CORTRUST BANK
RAMSEY, MINNESOTA

OVERALL LANDSCAPE PLAN
L1.1

L1.1 OVERALL LANDSCAPE PLAN.pdf V1 - Changemark Notes (6 Notes)

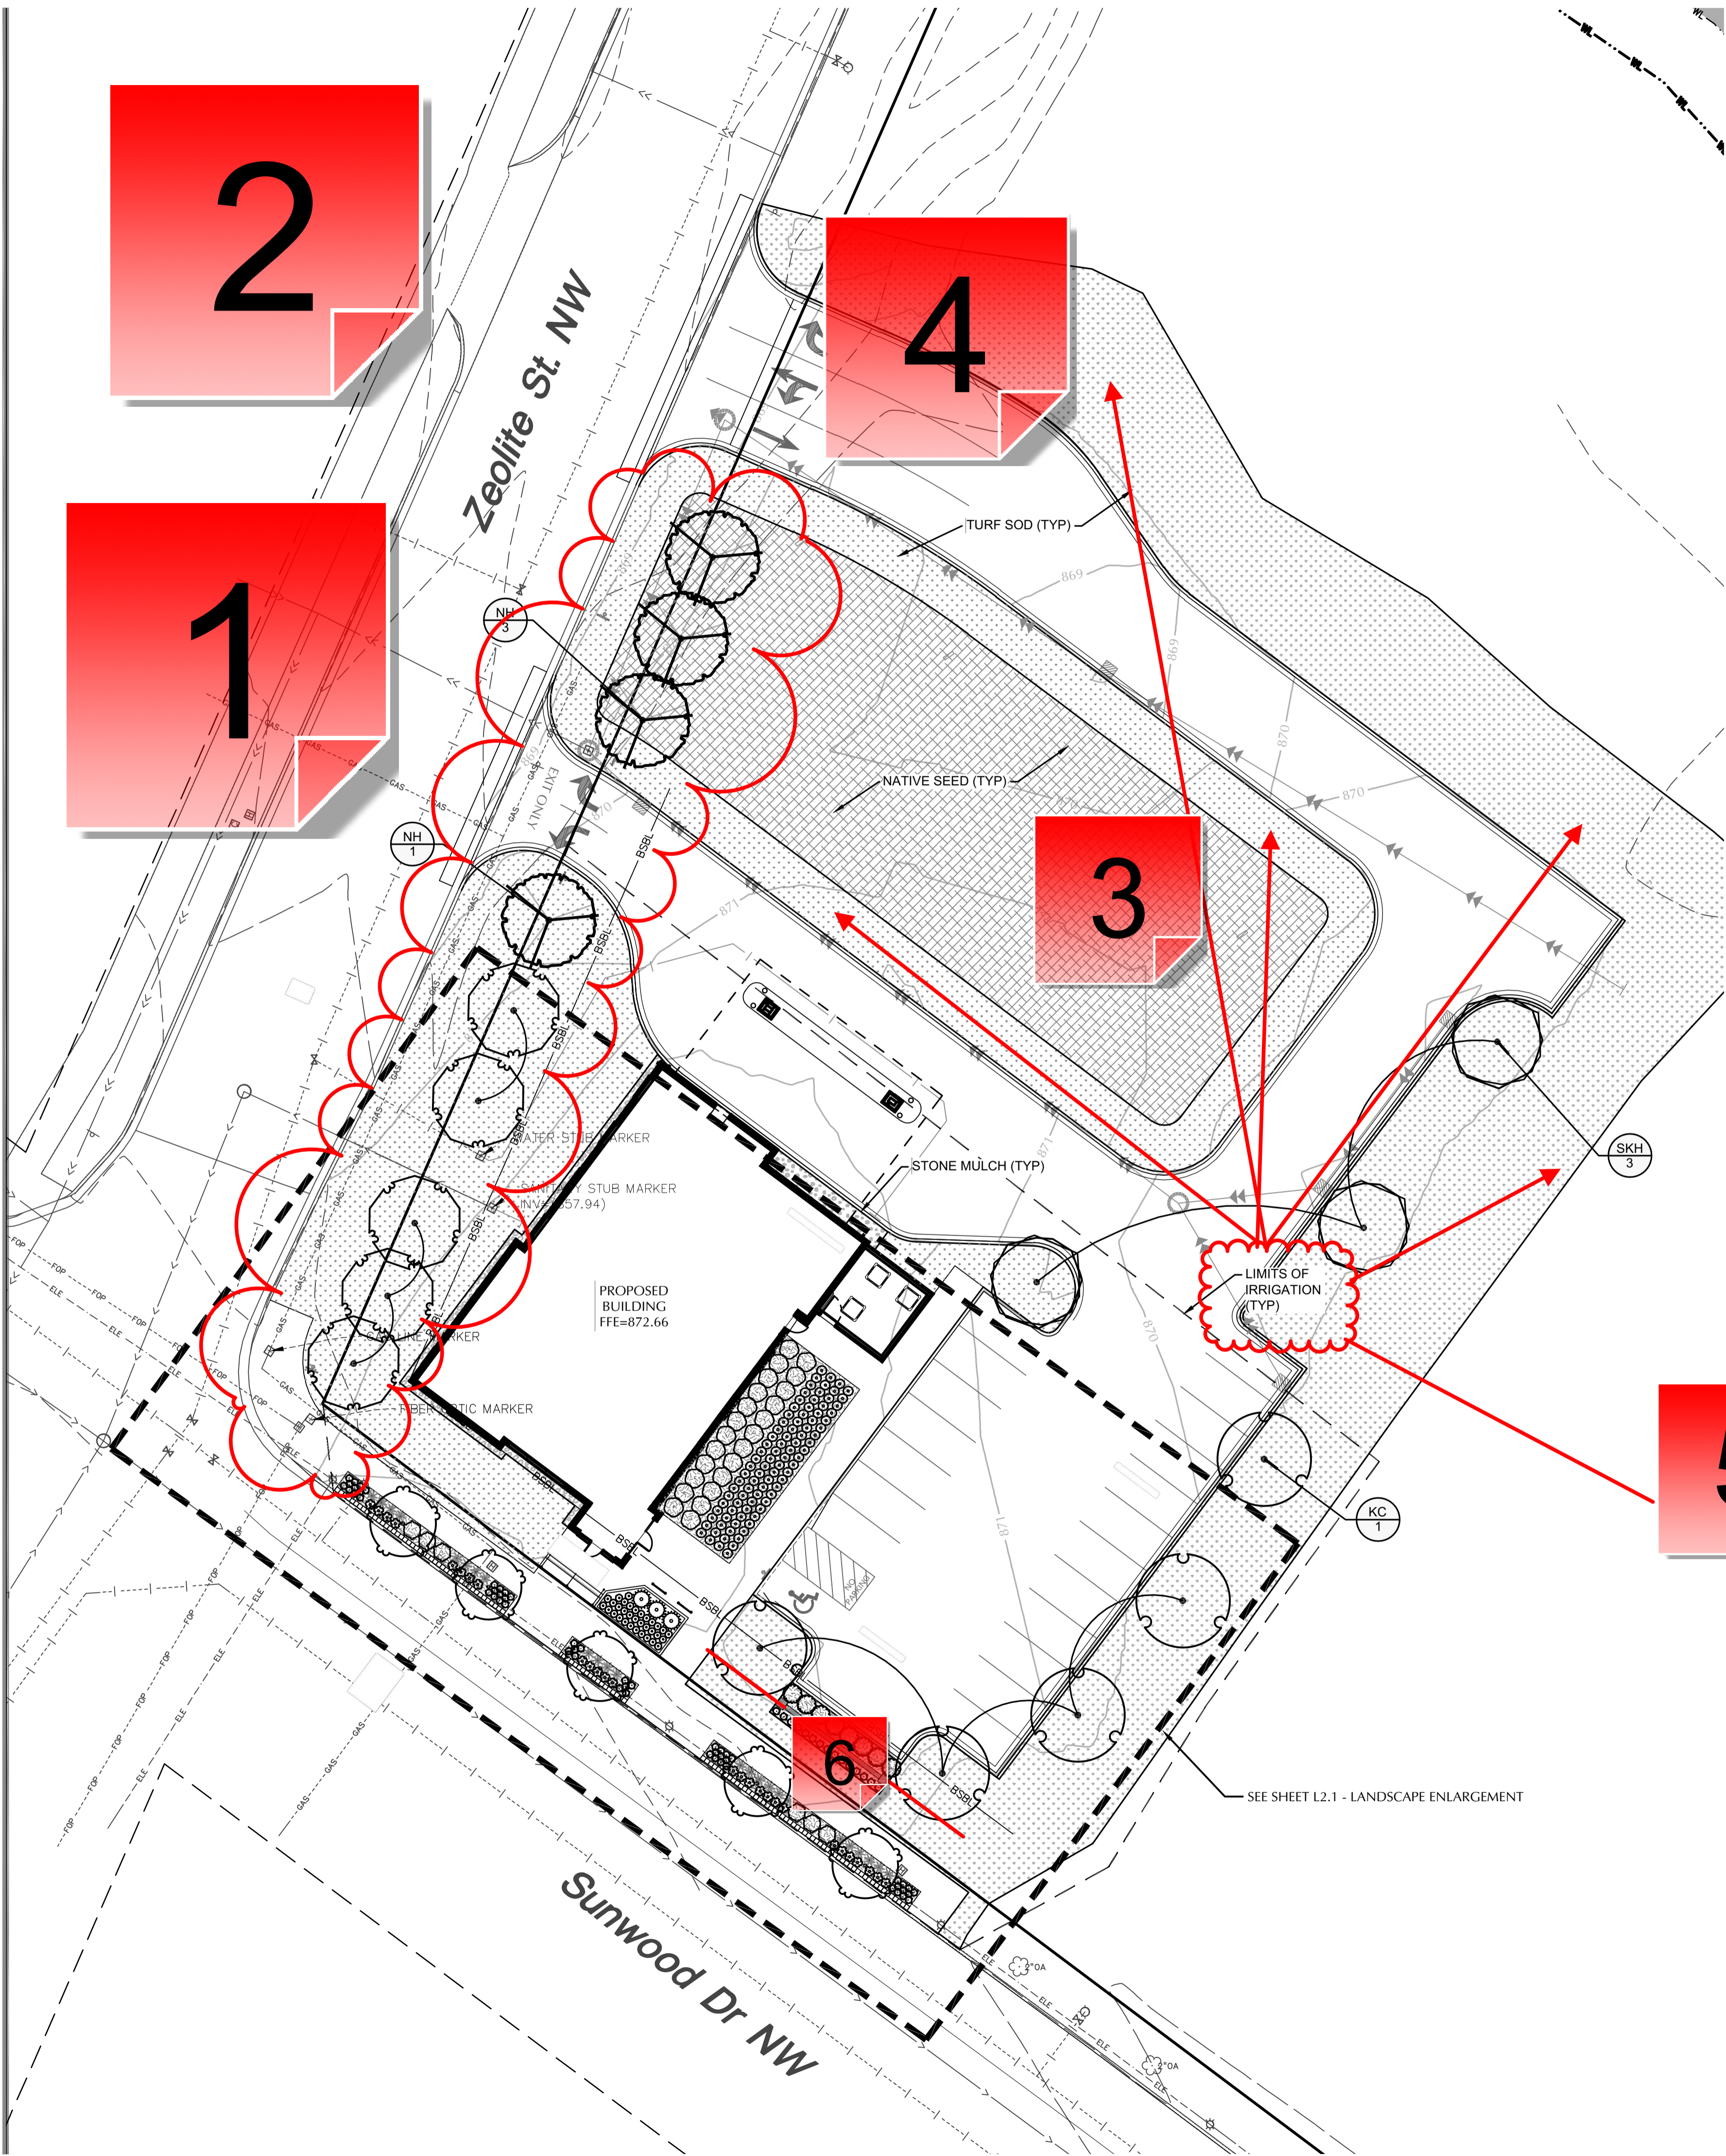
Along Zeolite Street, there shall be a boulevard at least six (6) feet in width and a concrete sidewalk that is at least six (6) feet in width.

In the boulevard, there shall be street trees planted at a spacing not more than 35 feet on center.

Acceptable species in the boulevard include the following: Bicolor Oak, Princeton Elm, Accolade Elm, Autumn Blaze Maple, Skyline Honeylocust, Kentucky Coffeetree, or River Birch (single stem only).

A 3-5 year maintenance plan is required if using this native seed mix. Please submit the maintenance plan for review. The maintenance plan must outline what maintenance activities are necessary, frequency, and time of year. A copy of the maintenance plan must be provided to the bank so that they know what they are required to do to ensure proper establishment.

With boulevard trees being required, it may not make sense to keep all these trees here, so it would be optional to retain them or they could be eliminated.

Why not extend irrigation to these sodded areas? They will be highly visible to all customers coming to the bank via vehicles.

The decorative knee wall needs to be extended to provide screening of the entire width of the parking lot from Sunwood Drive. The height of the knee wall shall be not less than three (3) feet and not more than 4.5 feet in height.
